Docket Number:	15-AAER-06
Project Title:	Small Diameter Directional LED Lamps and General Purpose LED Lamps
TN #:	215140
Document Title:	Response to Comments: General Services LED Lamps and Small Diameter Directional Lamps Rulemaking
Description:	N/A
Filer:	Soheila Pasha
Organization:	California Energy Commission
Submitter Role:	Commission Staff
Submission Date:	1/3/2017 12:38:23 PM
Docketed Date:	1/3/2017

Response to Comments: General Services LED Lamps and Small Diameter Directional Lamps Rulemaking

DOCKET #15-AAER-6

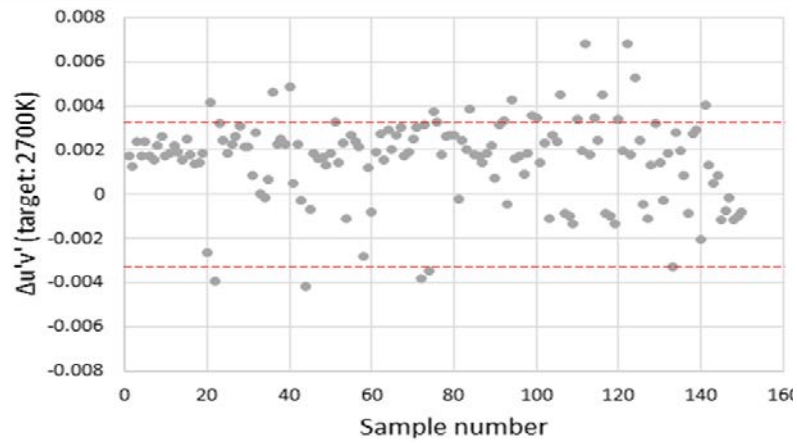
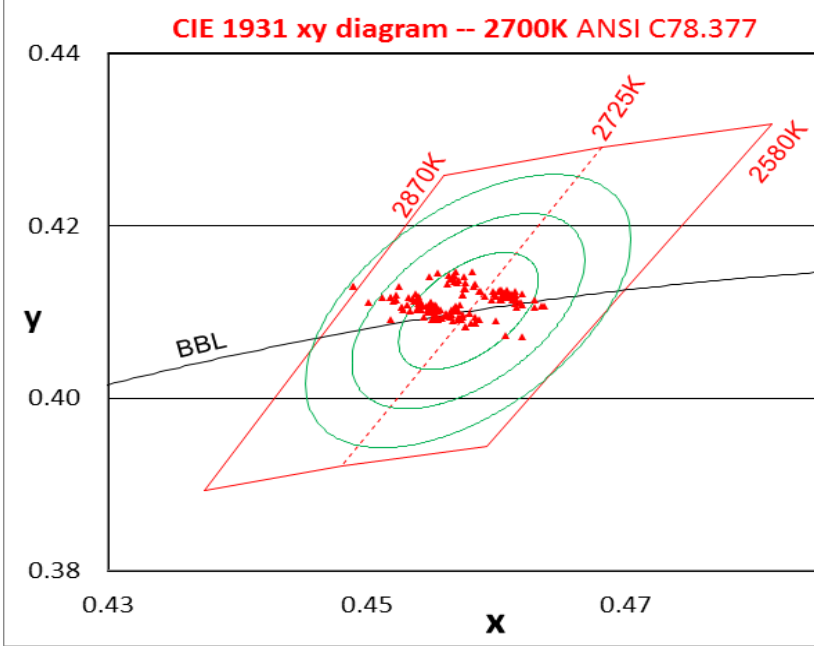
Philips	<p>In addition to limits on R1 - R8 and CRI, the Commission has proposed limits on Duv, which is a seldom used metric that describes how far the light source color is from the black body locus. The proposal that appears in the 45 day</p>	<p>Staff modified the color consistency and chromaticity requirements in 15-day language to state “A color point that meets the requirements in Table 1 of Annex B of ANSI C78.377- 2015 for</p>

<p>language is as follows: $-0.0033 \leq Duv \leq 57700 \times (1/T)^2 - 44.6 \times (1/T) + 0.00854$, where T means the measured correlated color temperature. At the public hearing, this was replaced with: $-0.0033 \leq Duv \leq 57700 \times (1/T)^2 - 44.6 \times (1/T) + 0.01184$, the difference being the quantity at the far right of the equation. These are rather tight limits for any SSL lamp to meet. As the Commission might be aware, in 2011 Philips Lighting was awarded the L-Prize by the DOE for our design of an SSL 60W replacement lamp. This lamp is one of the most highly designed and tested lamps in the history of lighting with extremely challenging performance characteristics.</p> <p>The following graph shows Duv data from 150 lamps sampled over 10 weeks of production for the commercial version of the L Prize design. Superimposed on the data are the Duv limits from the equation presented at the public hearing. These data show that not even this award winning design will meet the Duv limits in the 45 day language.</p> <p>Duv Data from Production for L-Prize Design</p>	<p>color targets and color consistency.” This approach is essentially identical to the Commission’s original Duv requirement, but is a more nationally recognized standard that manufacturers expressed more comfort with.</p> <p>The Commission declined to adopt a 7-step ANSI quadrangle approach because it would allow too great a deviation from the black body locus (white light) and too great an inconsistency between two light bulbs, issues that were of concern in CFL adoption. The 4-step ANSI quadrangle approach provides addresses these issues, is cost effective, and is technically feasible.</p>

These same data are replotted below with MacAdam ellipses of 3, 5, and 7 steps. All of the 267 points are within 7 steps and 90% are within 4 steps.

Based on these data, from a product with an extremely tightly controlled design, we believe that we have demonstrated that the proposed Duv limits are too restrictive. We recommend instead that the Commission adopt ANSI 7-step quadrangles for the color limits.

The Energy Commission established standards for lamps that were blind to specific models or technologies. The Energy Commission modified its regulations related to chromaticity and color consistency in 15-day language to allow use of national standards, such as ANSI C78.377-2015,

Average Online per Kilolumen Price Trends for A-lamps

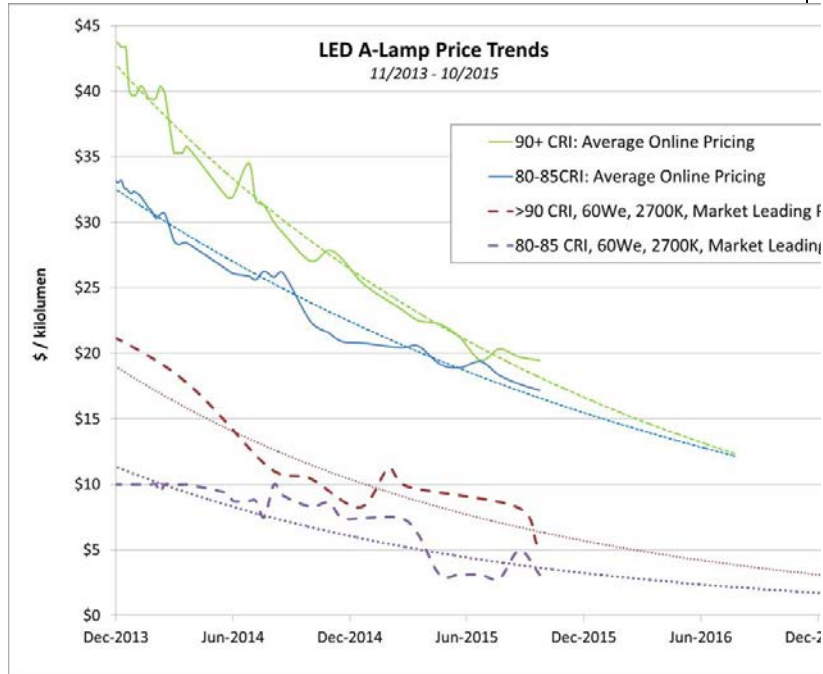
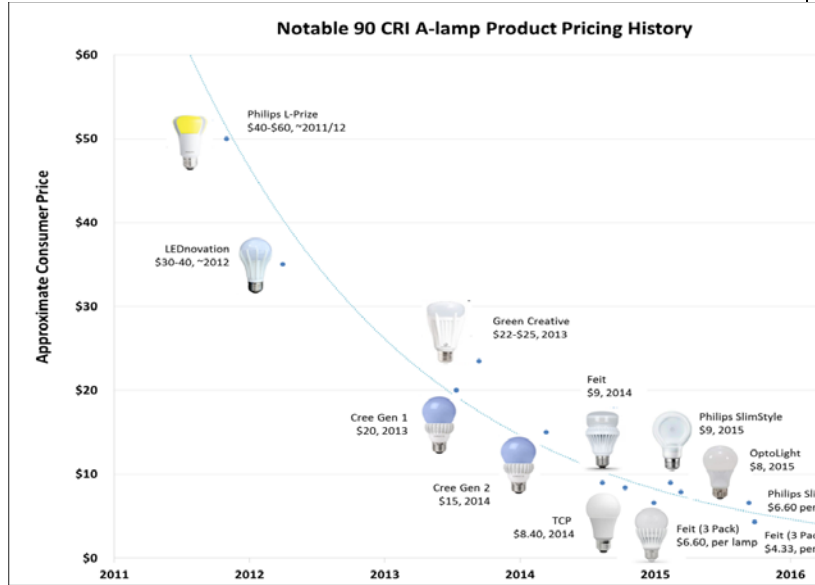
2) >= 55 LPW if the CRI is 90 greater	
California IOUs	<p>Price Trends for high CRI products: Prices are falling quickly for all LEDs, but they are falling more rapidly for higher CRI products. The CASE team has been monitoring LED pricing, regularly obtaining thousands of price points from online retailers, as well as tracking individual price points of high CRI products, including those that meet the CEC Voluntary Specification. Figure 2 below shows average online pricing per kilo lumen based on A-lamp prices collected from nine online retailers between late 2013 and fall 2015. In less than two years, average pricing of low CRI products came down by about 47%, but the average pricing of high CRI A-lamps came down by about 58%. The graph also shows market-leading price trends for low and high CRI products. Again, the best high CRI prices have come down more quickly and continue to catch up to the best lower CRI prices.</p> <p>Exponential trend lines (dotted lines) provide a possible forecast. These macro-level results are corroborated by specific product launches from the past several years. Figure 3 (In the IOUs comment letter) below highlights many of the notable high CRI A-lamp product releases and new price point offerings. Since late 2014, a number of products have been released from multiple manufacturers below \$10. The latest pricing as of late 2015 includes multiple products</p>	<p>This comment supports the staff report analysis.⁷ No change is needed.</p>

below \$7, including one as low as \$4.33.

Figure 14. Time Series Analysis of Availability of Products that Meet the Proposed Standards: January 2014 - August 2015

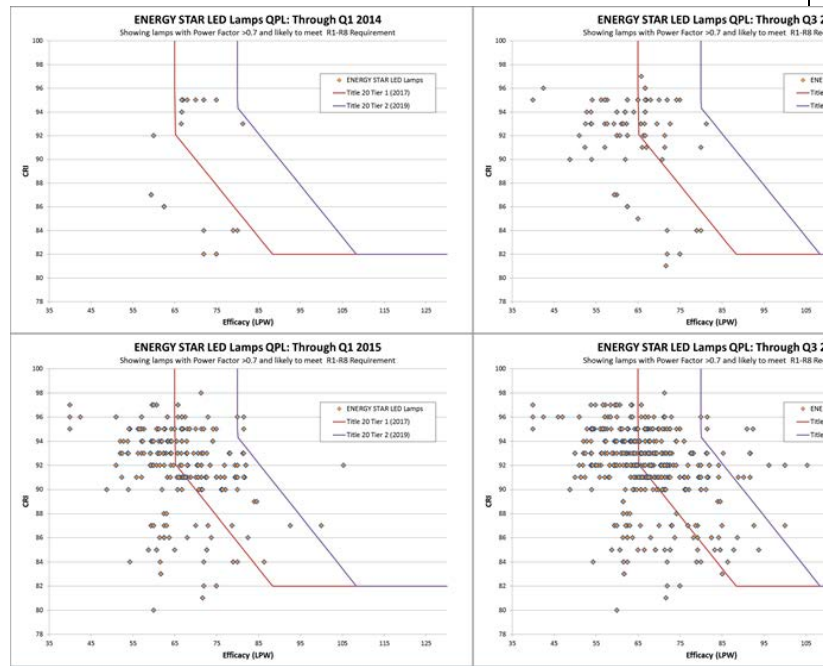
California IOUs	<p>Performance Improvement Trends: In addition to the data indicating that current products are available that meet the proposed standards, the trends in the LED market suggest that more products will be available by the time the standard takes effect in 2017. The market is expected to experience even more significant improvement before Tier 2 standards take effect in 2019. Assuming current trends continue, omnidirectional lamps will increase in efficacy by 30% between now and 2019; directional lamps will increase by 23%. Decorative lamps are experiencing the fastest efficacy improvement; if their current improvement trends continue; decorative lamps will be 33% more efficient by 2019. Figure 14 below highlights the rate of improvement over the last two years, in terms of the total number of products in the ENERGY STAR QPL that meet all the proposed requirements. The four graphs show progress updates on a 6 month schedule, starting with Q1 2014 in the top left.</p>	<p>This IOUs comment is in support of the proposed regulations and provides information on the market and availability of the regulated products in the future. In the revised 15-day language published on January 7, 2016, staff made changes to accommodate stakeholder comments. These changes included giving industry more time to meet the proposed standards by moving the Tier 1 requirements' effective date from January 1, 2017 to January 1, 2018, and delaying implementation of the Tier 2 requirements to July 1, 2019. No change is requested in this comment or further changes needed.</p>

Comparison of R8 to CRI (Ra) in LED Lamps

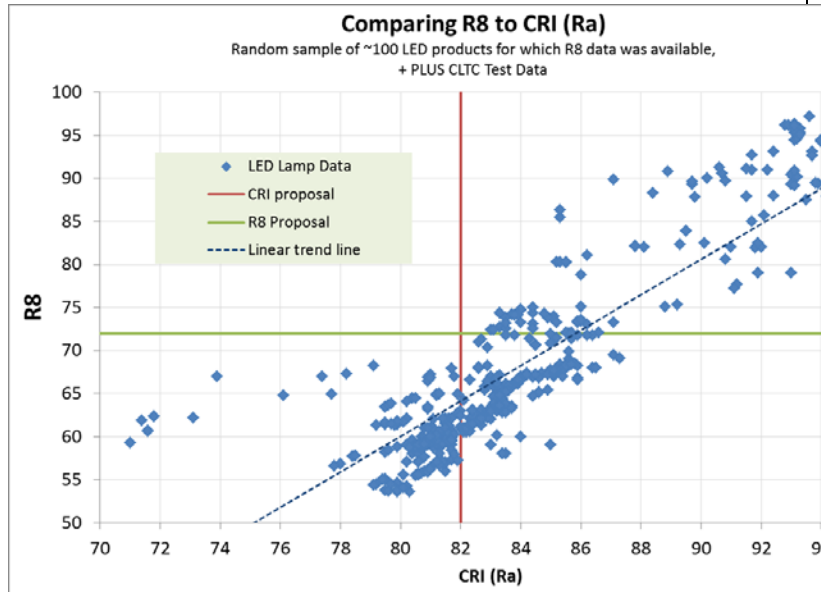
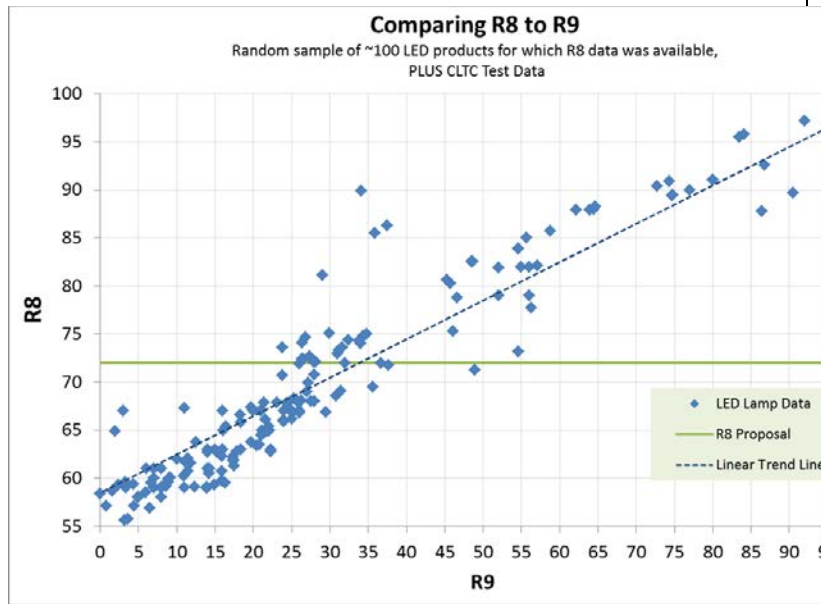
<p>understand the relationships between R8 and CRI, and between R8 and R9. Understanding these relationships helps us to better analyze the publically available data using proxy data for R8. Figures 5 and 6 below provide this analysis. Figure 5 demonstrates that the relationship between R8 and CRI is not perfect, but it is good, with an R value of 0.73. The figure also shows that among products with a CRI of 85, about half have an R8 value above 72, and above 88 CRI, all products have an R8 above 72. Figure 6 shows that the relationship between R8 and R9 is even stronger, with an R value of 0.84. This graph shows that among products with an R9 score of 30-35, most products (about 75%) have an R8 above 72. These analyses have helped us to interpret Lighting Facts Database and the ENERGY STAR QPL. For our purposes, we have used an R9 score of 32 as an approximate comparison for an R8 score of 72, since that is the intercept of the trend line and above that point we see that most products meet an R8 of 72. However, to be certain, and to take a conservative approach to analysis of compliant products, we also know that products with a CRI above 88-90 will more definitively meet the posed R1-R8 requirement.</p>

The comment supports the standards and does not ask for changes to the standards.

Figure 15. 2014 Average Online Pricing for Dimmable vs. Non-Dimmable LED Lamps

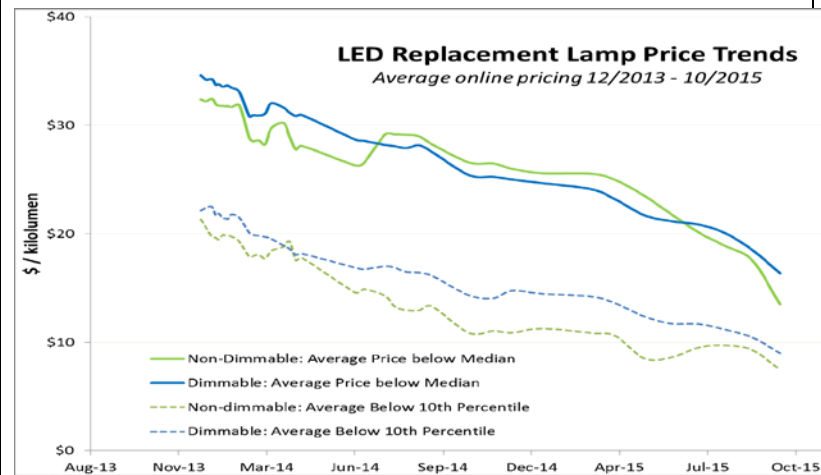
Additionally, as shown in the figure below, online prices for dimmable LED replacement lamp products (based on price points from hundreds of products) are occasionally slightly lower than prices for non-dimmable products. This suggests that any incremental manufacturer cost associated with making a product dimmable is negligible. It also stands in stark contrast to the CFL market, where historically few products were dimmable and they carried significant incremental retail prices.

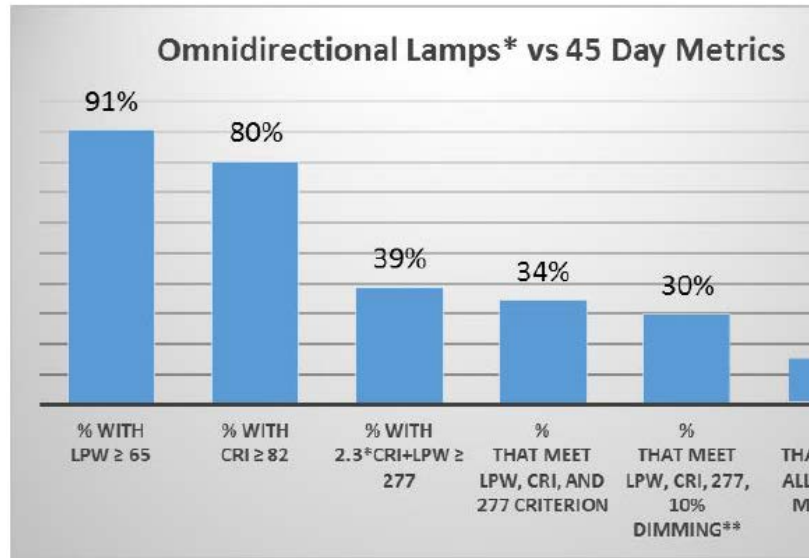
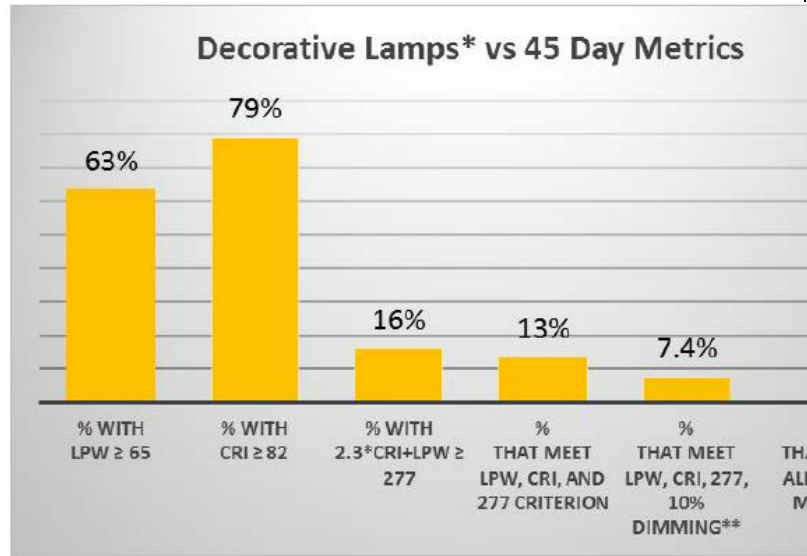
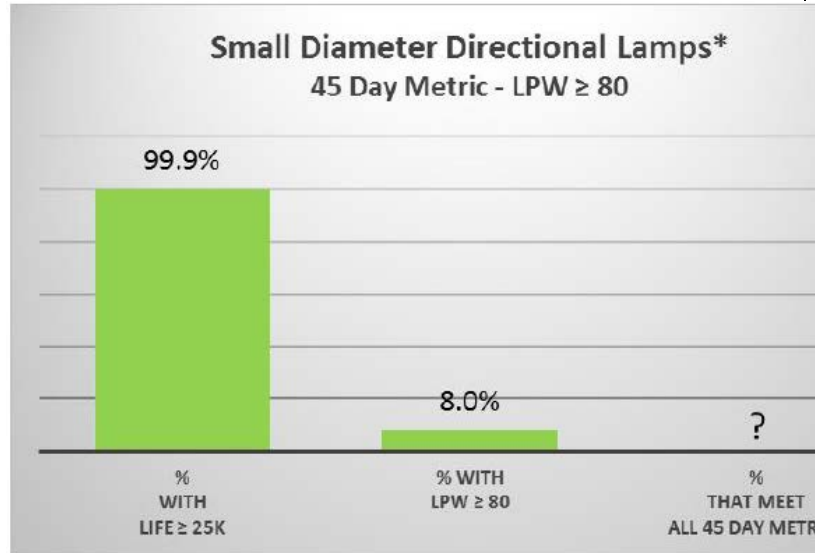
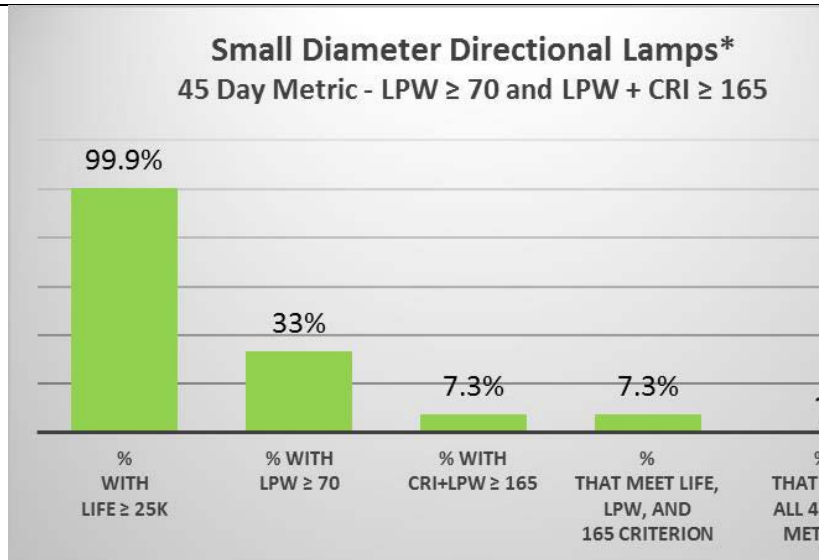
Philips	At a minimum, it can be said that <u>at least 70% of the omnidirectional models currently in the market would not meet the Tier 1 requirements in 2017</u> if the Title 20 language is adopted as written. Other required metrics such as R1-R8 and Duv do not appear on the certified products list. Thus we expect that roughly 90% of the omnidirectional lamps will not meet the requirements. This is based on our knowledge of the metrics since the R1-R8 requirement	See RESPONSES 3, 9, and 10.

excludes all lamps with a CRI < 85 and the Duv requirements are overly strict.

Similarly, we looked at the data for the lamps characterized as decorative. The data show that at least 92% of the 705 decorative lamps on the Energy Star list will not meet the proposed Title 20 combined criteria for efficacy, CRI, Tier 1 equation, and dimming. As with the omnidirectional lamps, when compliance with the R1-R8 and Duv criteria is factored in, the percentage of compliant lamps will be reduced even further. Again, with less than 7.5% of the existing decorative LED lamps unavailable in 2017, consumers will continue to use decorative halogen/incandescent lamps and CFLs. This will reduce the anticipated energy savings. The rulemaking

file does not appear to contain any evidence that the Commission accounted for this in their analysis.

The situation with small diameter directional SSL lamps is similar. The proposed 45 day language has two paths for product compliance: lamps with an efficacy of 80 LPW or greater, or lamps with an efficacy of 70 LPW and a combined score of CRI + LPW ≥ 165. In either case, analysis of the lamps on the certified product list shows that 8% or less of the 741 existing lamps will meet the 45 day metrics. This is illustrated in the graphs that follow. Thus, conservatively speaking, 92% of the currently available small diameter directional LED lamps will not be available to California consumers. This is illustrated in the graphs

Proposed Compliance Equations and Medium Screw Base Omnidirectional Performance Data from Energy Star and Lighting Facts Lists See RESPONSE 3.

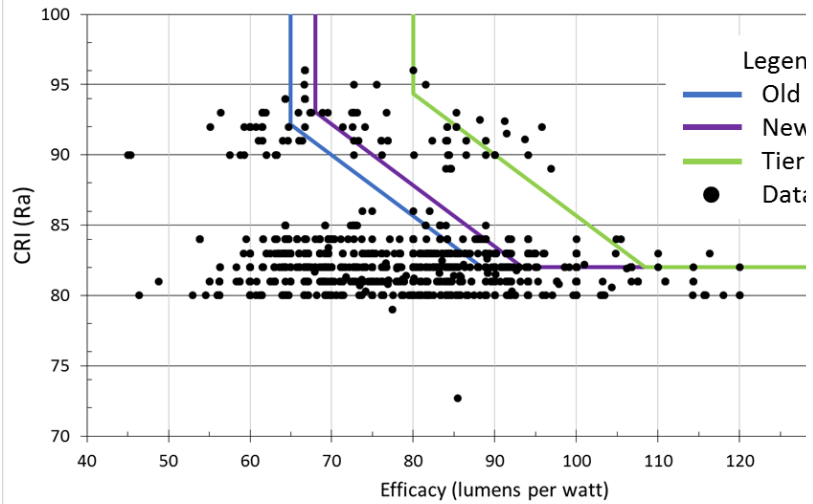
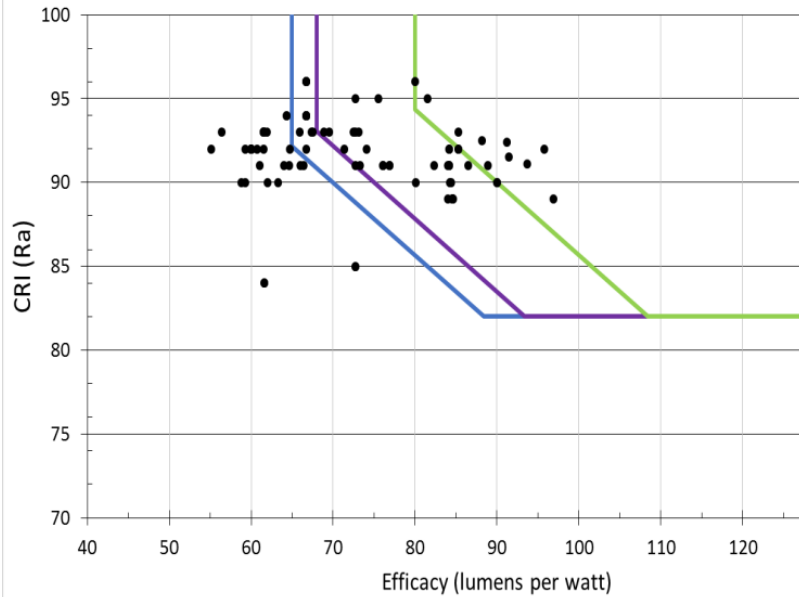
The foregoing graphs copied from the IOU comments to 45-day language seek to illustrate their claim that lamps with an R8 of 72 have a CRI close to 90. They are based on data for omnidirectional lamps taken from the ENERGY STAR and DOE LED Lighting Facts lists. Both show CCT's less than or equal to 3000K. The second figure shows that
